BOROUGH OF OCEANPORT PLANNING/ZONING BOARD

10.1. PB2025-12 Netflix, Phase 2A
    Block 105, Lot 1.01
    Application for Major Site Plan of Phase 2A. The subject property is known as Zone 6 of the Mega Parcel. All existing structures are to be razed except for five buildings (buildings 277,482,279, 280 & 281). Applicant proposes the adaptive reuse of the five structures for storage and warehouse purposes. Site improvements include repaving of existing parking lots, access drives, site lighting, security wall, installation of stormwater collection system, and landscaping.

Application No. PB2025-08
59 Main Street
Block 110, Lot 10
Borough of Oceanport, Monmouth County, New Jersey
Colliers Engineering & Design Project No. OPP-0371

Drawing No. CT203
Sheet 27 of 64

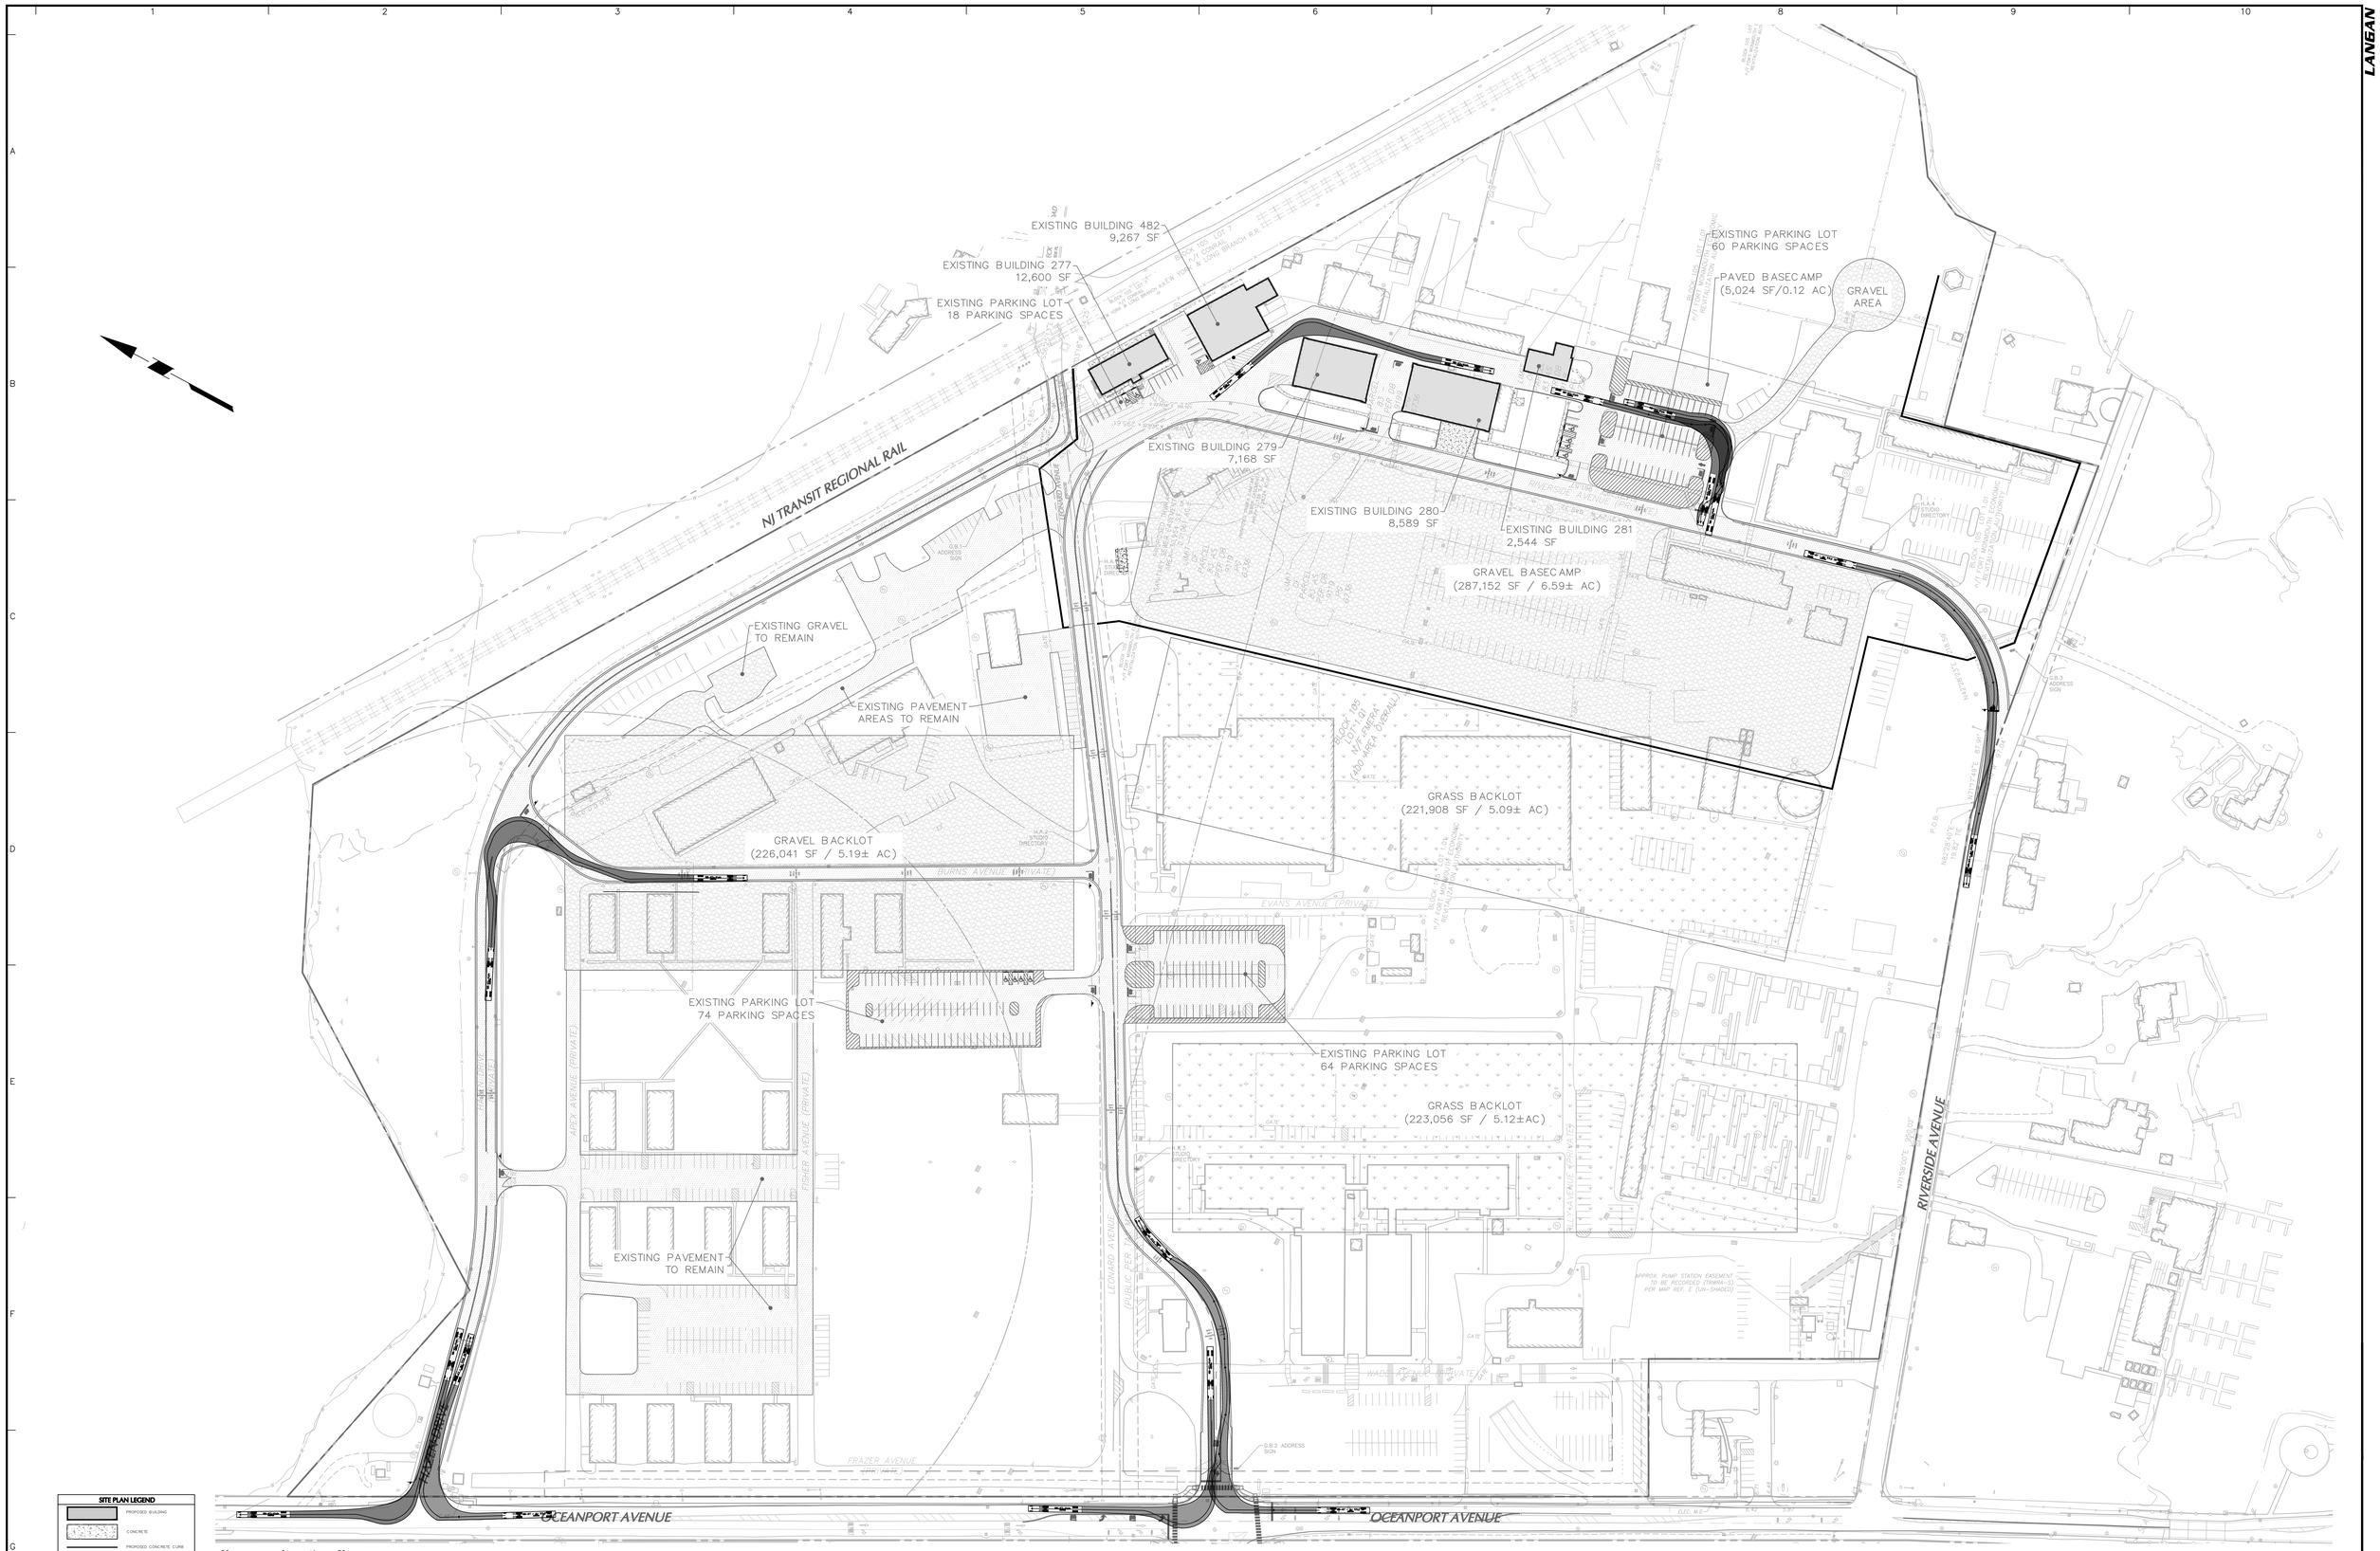
6. The Site Triangle Plan, Sheet CT203 of the Preliminary and Final Major Site Plan, illustrates the available intersection sight distances (ISD) at the following intersections:
   a. Oceanport Avenue (CR 11) & Hazen Drive:
      i. Available left-turn ISD = 680 feet; where 680 feet is required for a design speed of 40 mph and a WB vehicle
      ii. Available right-turn ISD = 620 feet; where 620 feet is required for a design speed of 40 mph and a WB vehicle

CG215
Sheet 32 of 64

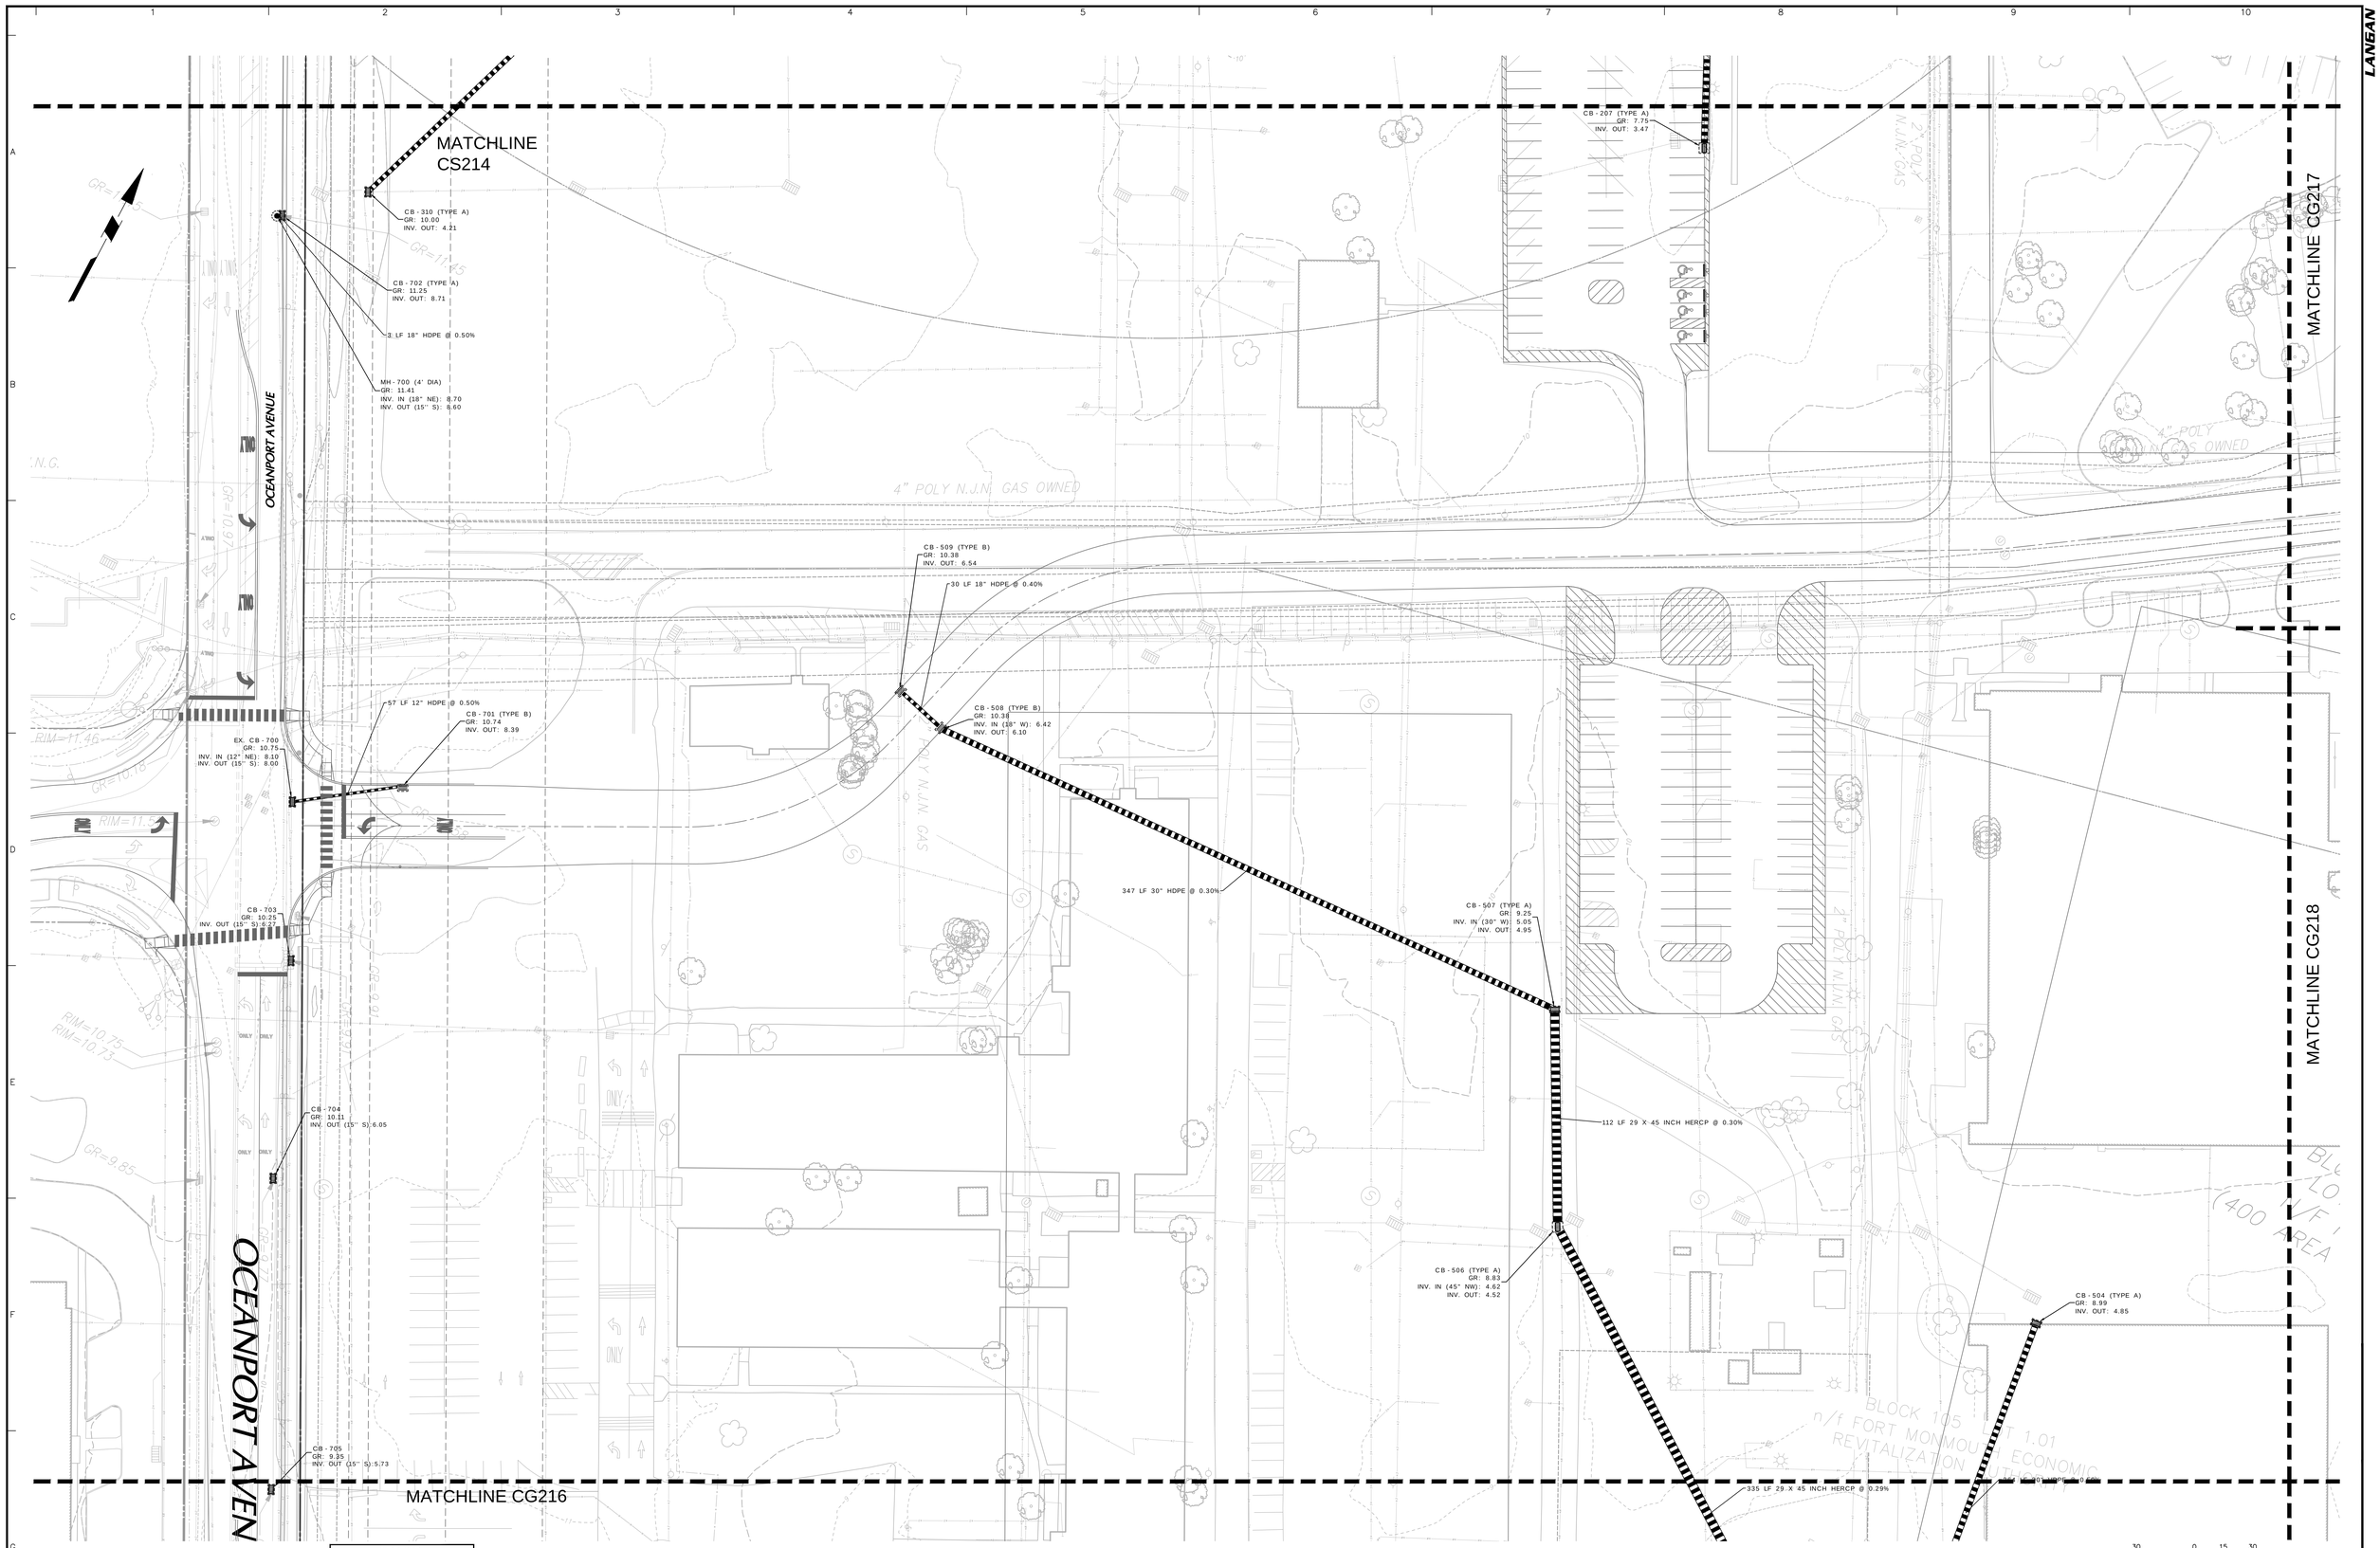
3. Sheet CG215 does not include the proposed grading.
